PUBLIC MEETING REVIEW

STEERING COMMITTEE COMMENTS

SITE DESIGN

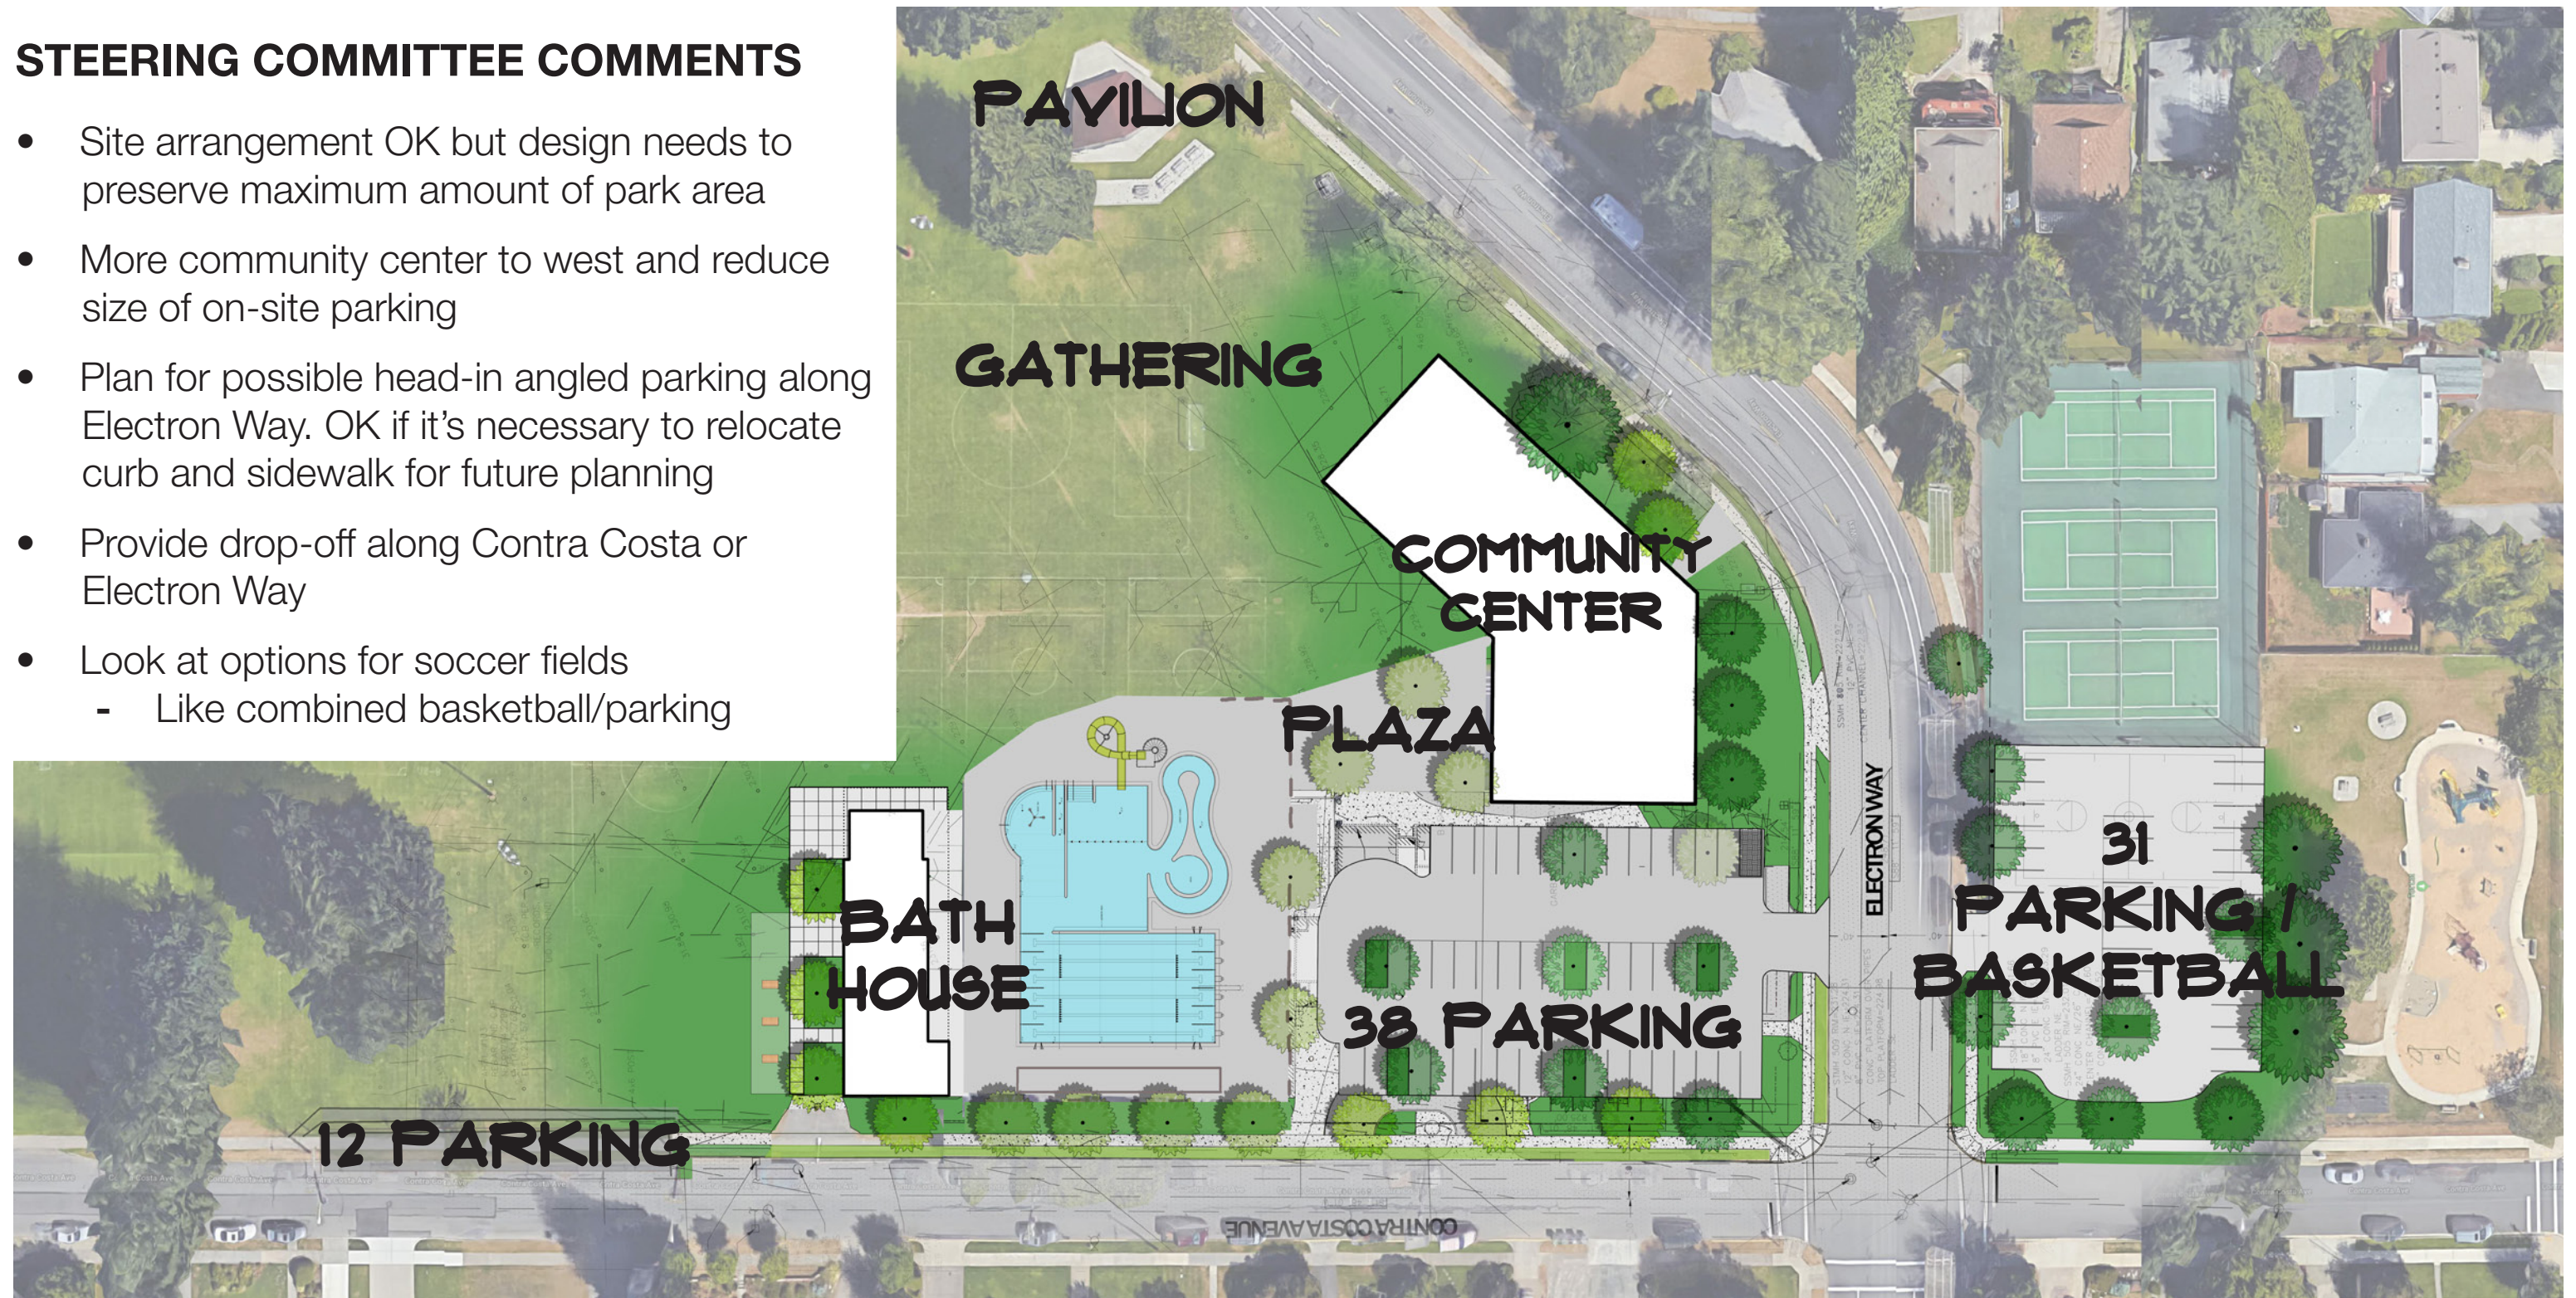
- Site arrangement OK but design needs to preserve maximum amount of park area
- More community center to west and reduce size of on-site parking
- Plan for possible head-in angled parking along Electron Way. OK if it's necessary to relocate curb and sidewalk for future planning
- Provide drop-off along Contra Costa or Electron Way
- Look at options for soccer fields
 - Like combined basketball/parking

BATHHOUSE DESIGN

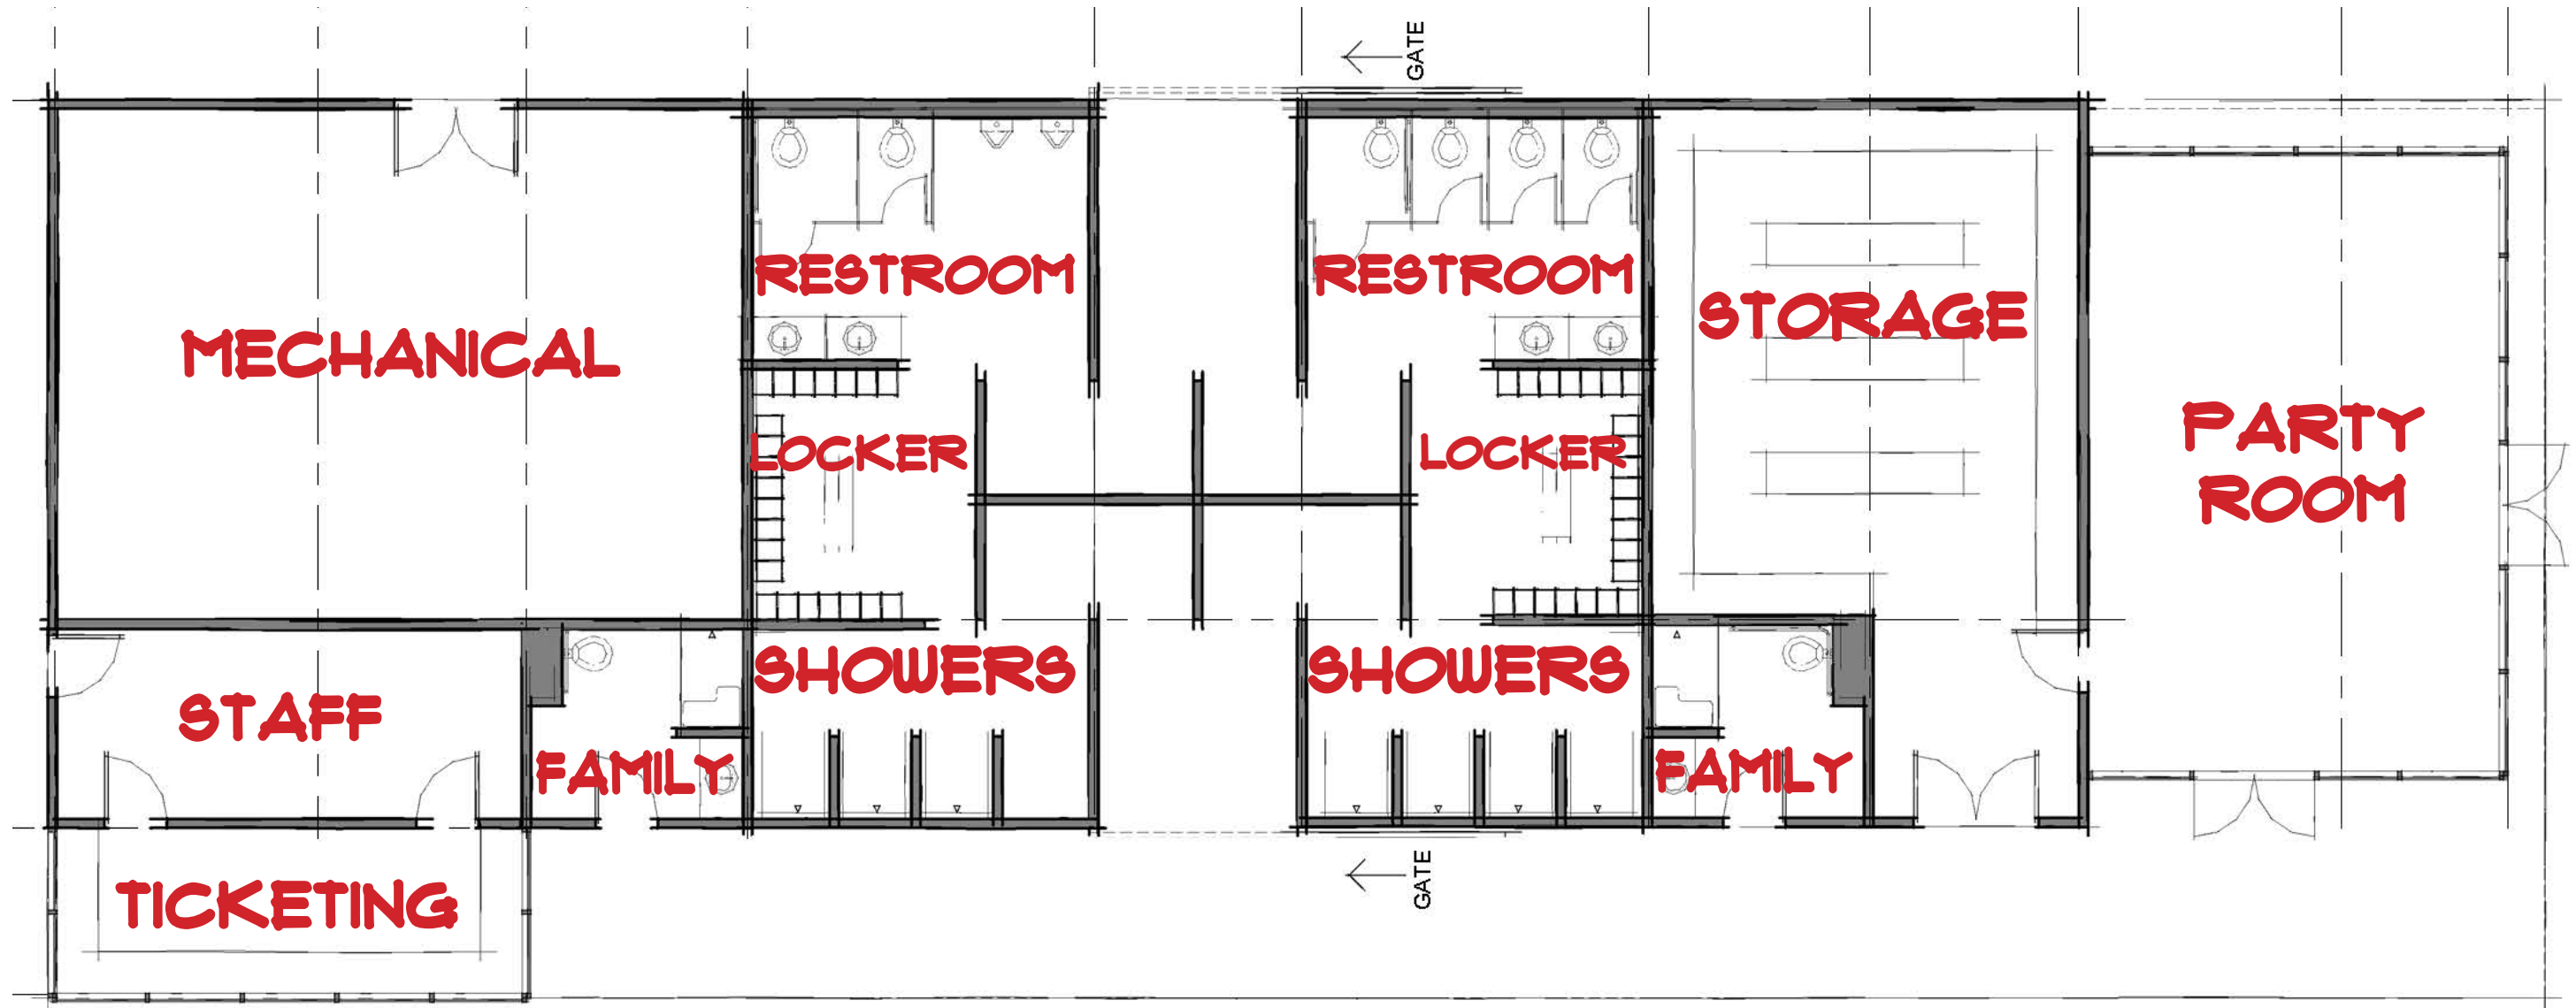
- Combined Pool and Park use of locker/toilet/shower areas not safe and hard to control
- Provide designated toilet facilities for the field, similar to original study
- Consider design of the party room so that it can work as a concessions stand

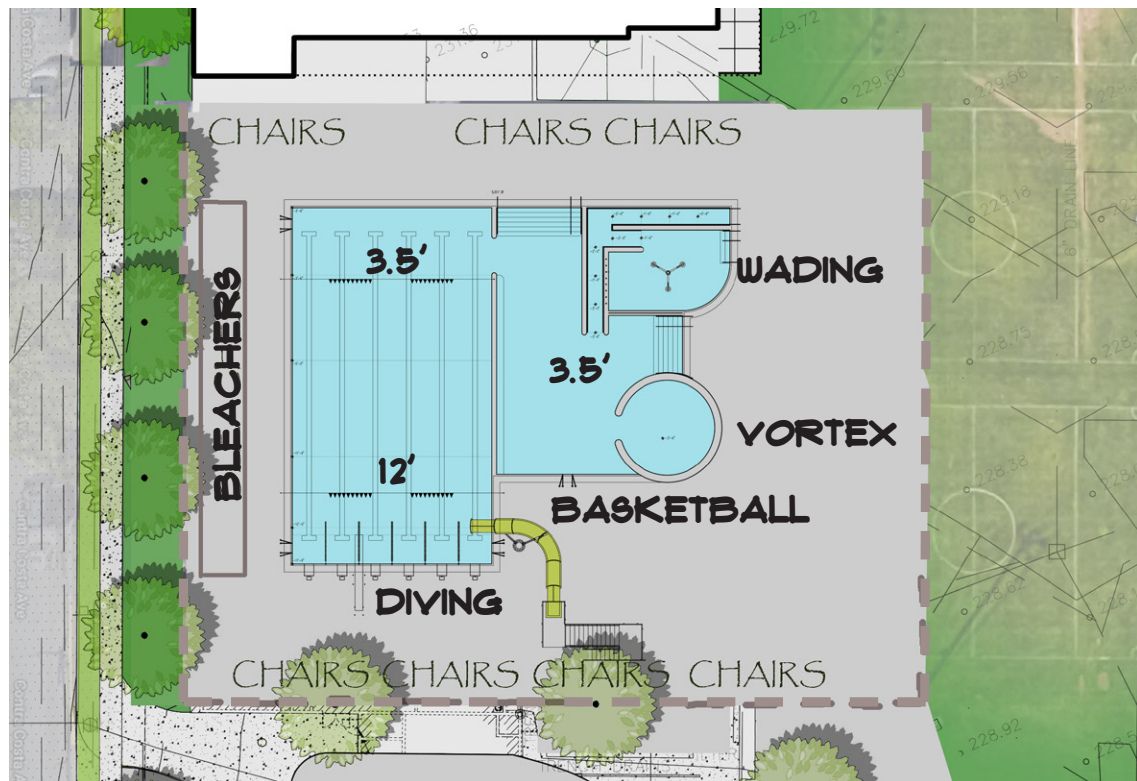
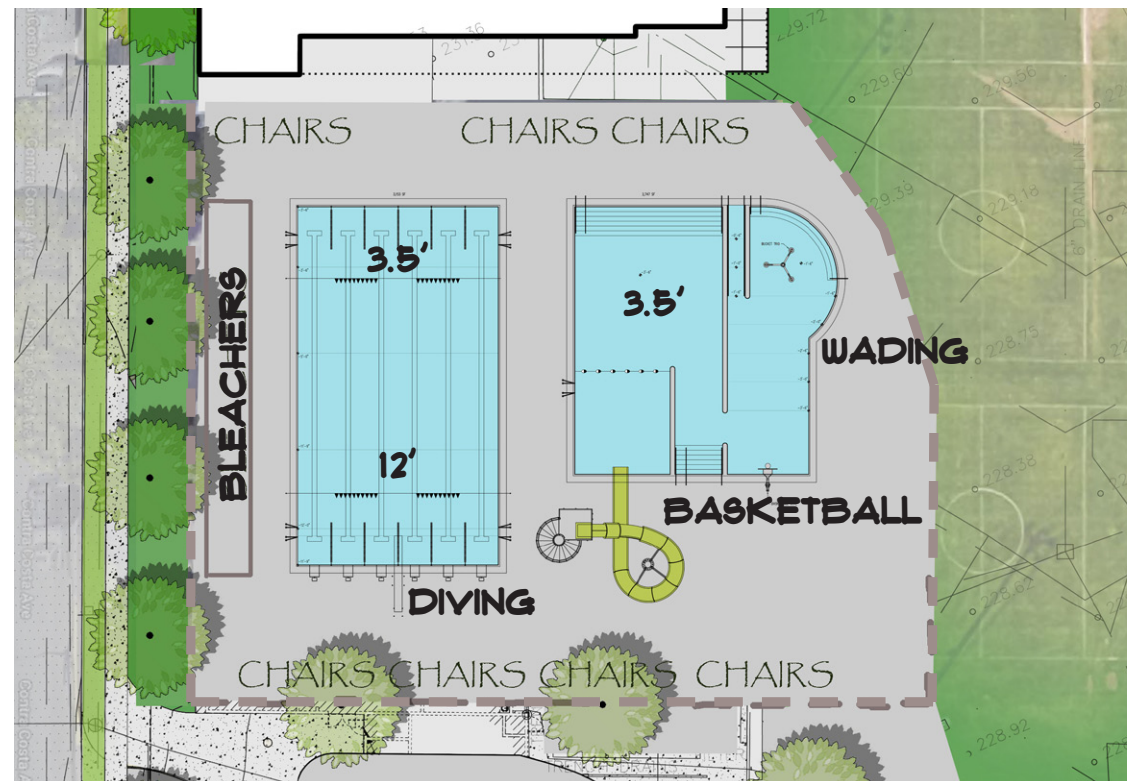
- Advance Option 3
- Advance Option 4
- Vortex gets more multi-age use than a slide, and takes less space than lazy river or channel
- OK to have diving at deep end, but move board so that more lanes are available during open swim
- Single tank costs less but water temperature is compromised
- Two tanks cost more but desired water temperatures maintained
- Kids 7 and under swim for free, so free use of wading pool area not an issue, plus lifeguarding provided
